Subject: Dresden Station Units 2 and 3  
 Quad-Cities Station Units 1 and 2  
 Supplement No. 1 to Dresden Station  
 Special Report No. 39 and Quad-Cities  
 Station Special Report No. 14, Analysis  
 of Hydrogen Generation and Control in  
 Primary Containment Following Postulated  
 Loss of Coolant Accident  
NRC Docket Nos. 50-237/249 and 50-254/265

Attached to this letter is Amendment No. 2 to Dresden Station Special Report No. 39 and Quad-Cities Station Special Report No. 14. This amendment is made up of revised pages 12-17, 21, 22, 66 and Figures IV.1, IV.2, IV.5, IV.6, IV.9, IV.11-IV.14.

Figure IV.1 Hydrogen concentration in the drywell (squares) and wetwell (circles) following a loss-of-coolant accident, without steam dilution

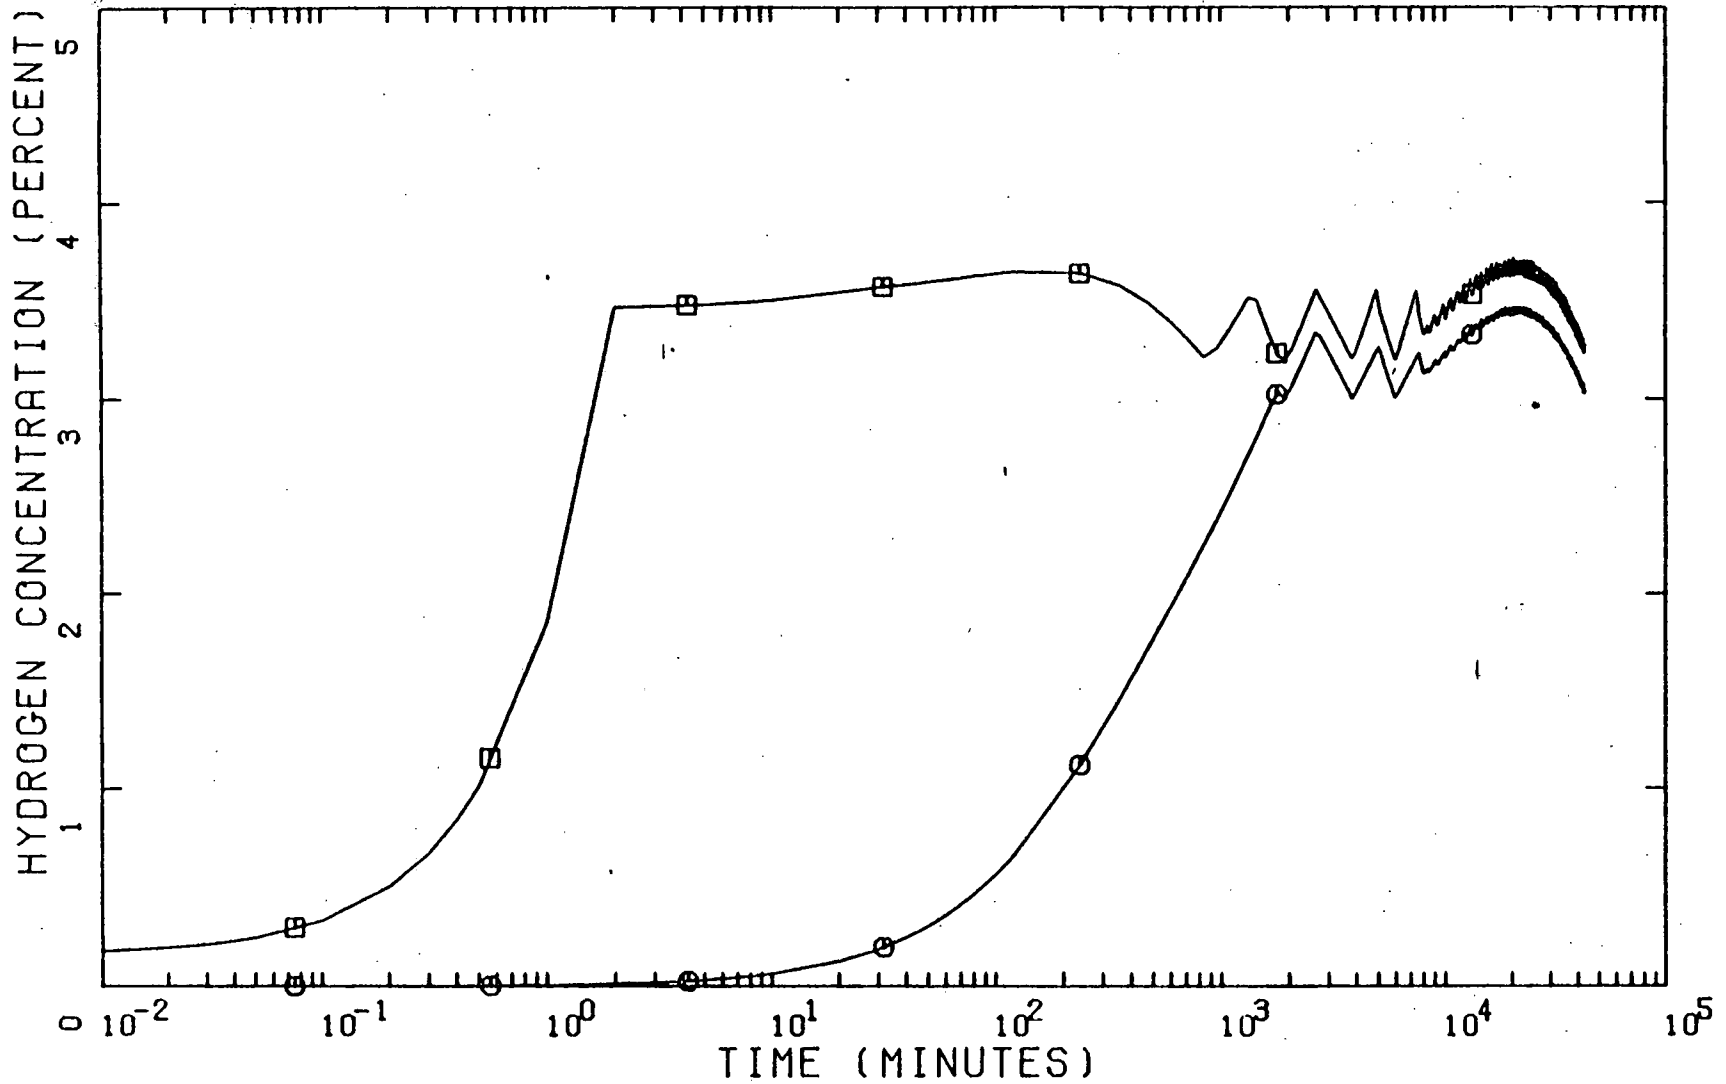
Please note that the hydrogen concentration in the wetwell without steam dilution, previously shown in Figure IV.4, is now shown in Figure IV.1, and Figure IV.4 has been eliminated. The drywell and wetwell pressures are now both shown in Figure IV.2, and Figure IV.3 has been eliminated. Similarly, the information previously contained in Figures IV.5 through IV.8 is now contained in Figures IV.5 and IV.6 and Figures IV.7 and IV.8 have been eliminated. Further, the information previously shown in Figure IV.10 is now shown in Figure IV.9 and Figure IV.10 has been eliminated.

To illustrate the effectiveness of the ACAD System operation the hydrogen concentration history in the drywell and wetwell is shown if no ACAD System was provided. By comparing Figures IV.1 and IV.9 the effectiveness of the system is clearly demonstrated.

Figure IV.5 Hydrogen concentration in the drywell (squares) and wetwell (circles) following a loss-of-coolant accident, with steam dilution

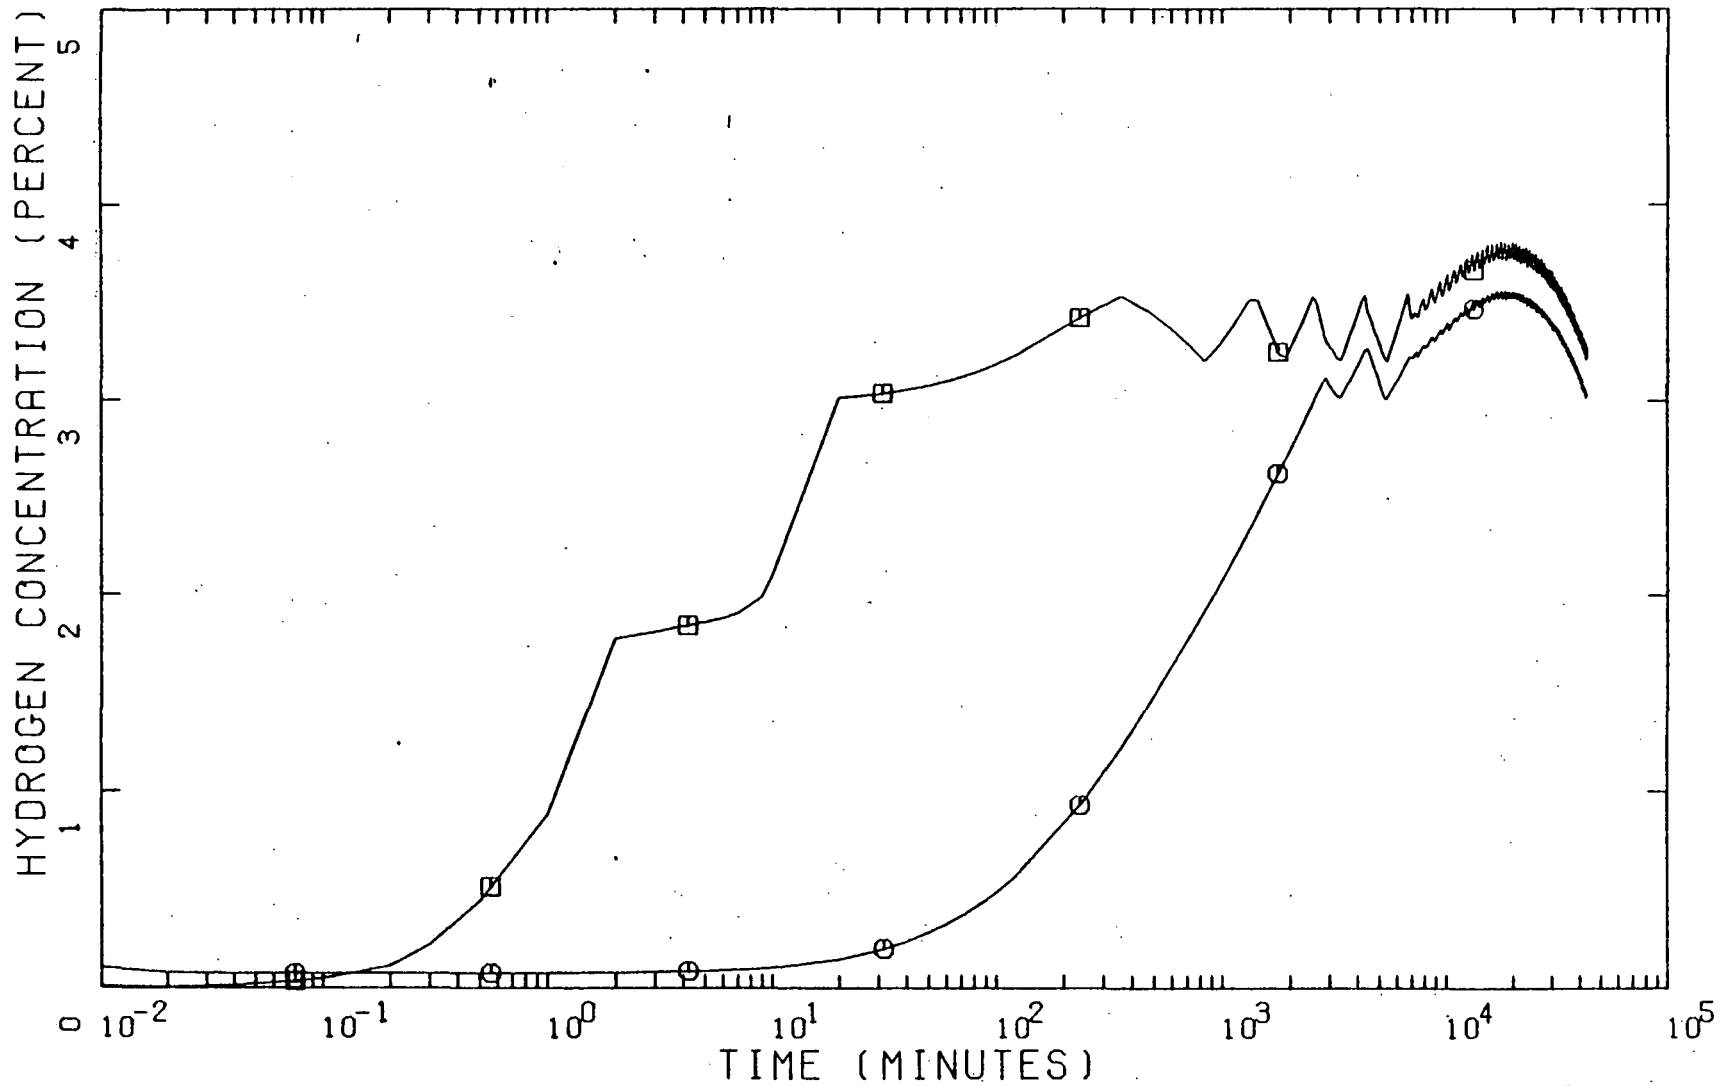
The results of this analysis shown in Figures IV.5 and IV.6 show that the ACAD System operation would not be required until 300 minutes (5.0 hours) after the accident, a factor of over 10 greater than the design case. The system would not be required to operate until much later than the design case, but when the air injection begins, the containment will be at a higher pressure than it is in the other case. As a result the

Figure IV.11 Probability Versus Thyroid Dose Quad Cities Units 1 and 2

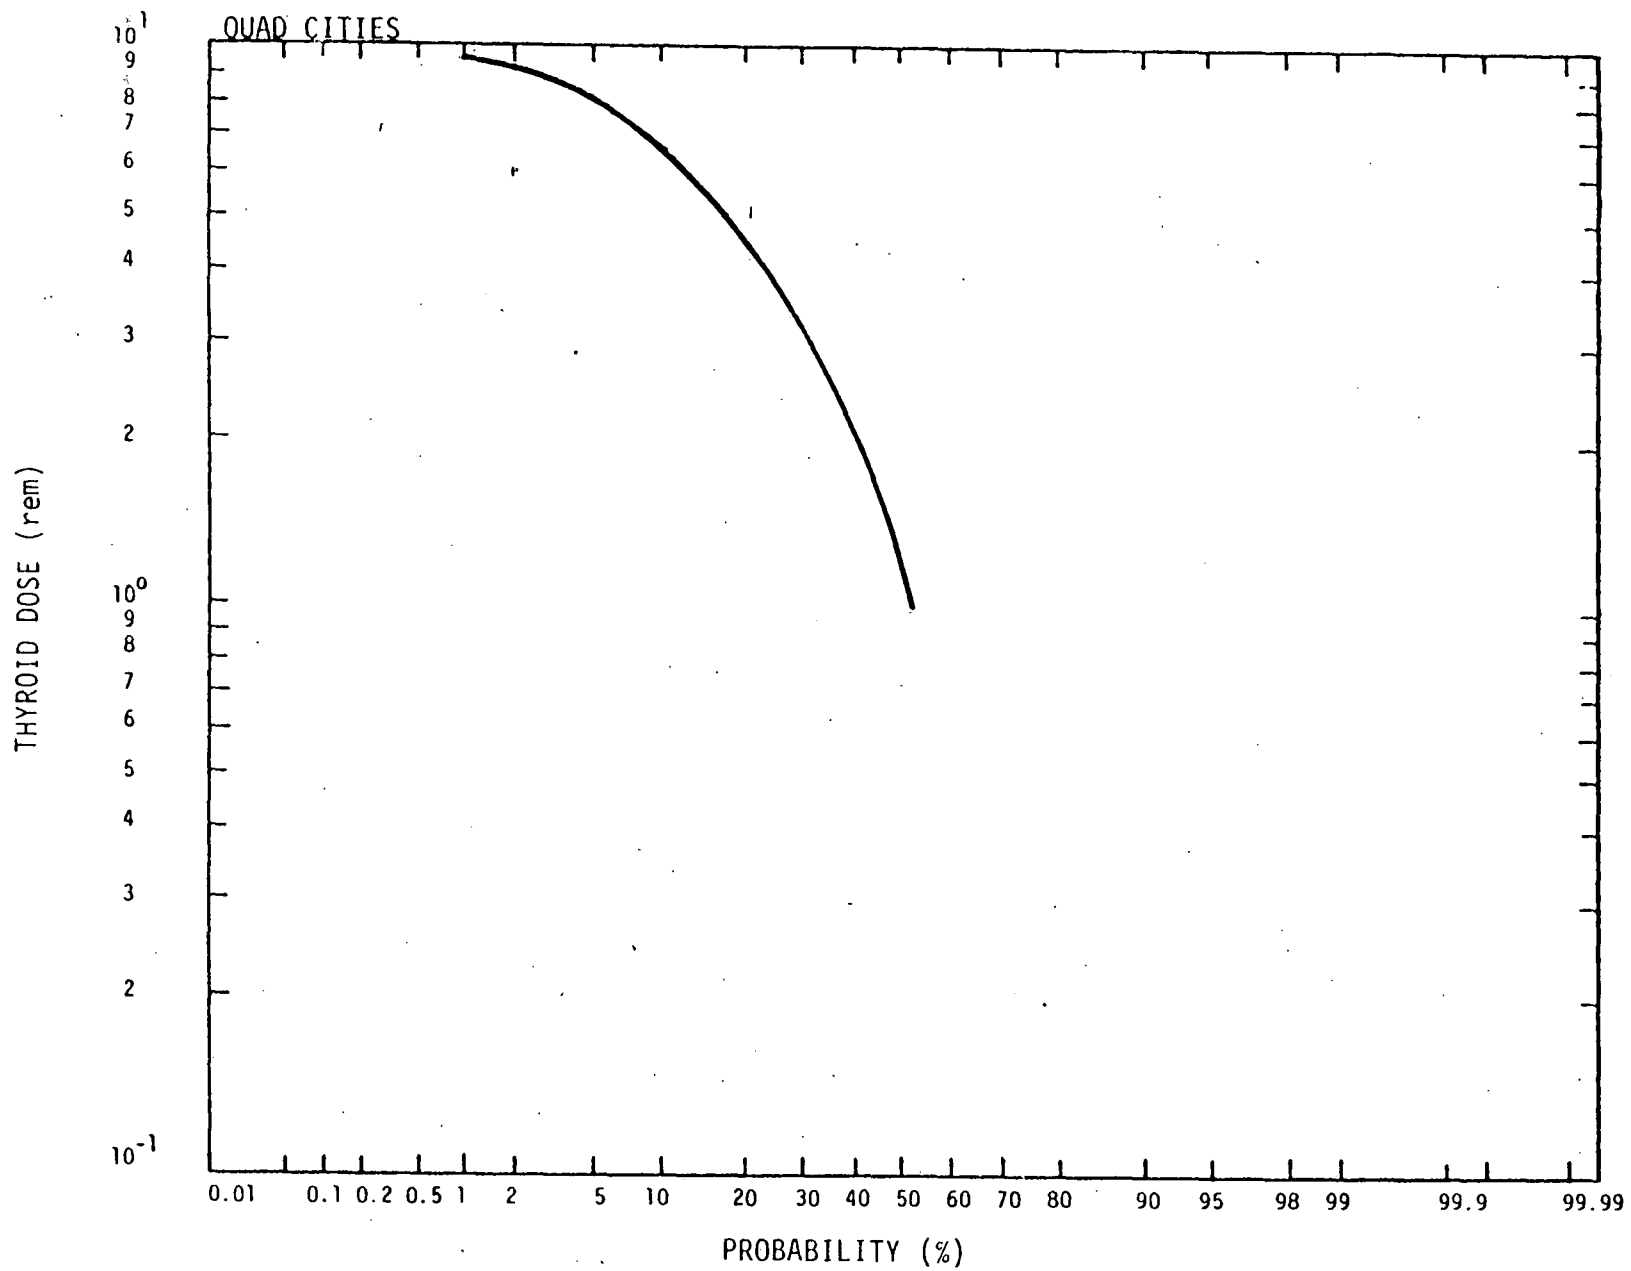
The results of this analysis are shown on Figures IV.11 through IV.14, where the probabilities of exceeding certain thyroid or whole body dose are plotted. Table IV.1 summarizes the results of the analysis by showing the 5% probable thyroid and whole body doses. These doses when added to the doses calculated for the LOCA by the USNRC Staff and documented in the respective station Final Safety Evaluation Reports (Refs. 11, 12, 13) are well below the 10CRF100 limits (Ref. 14).
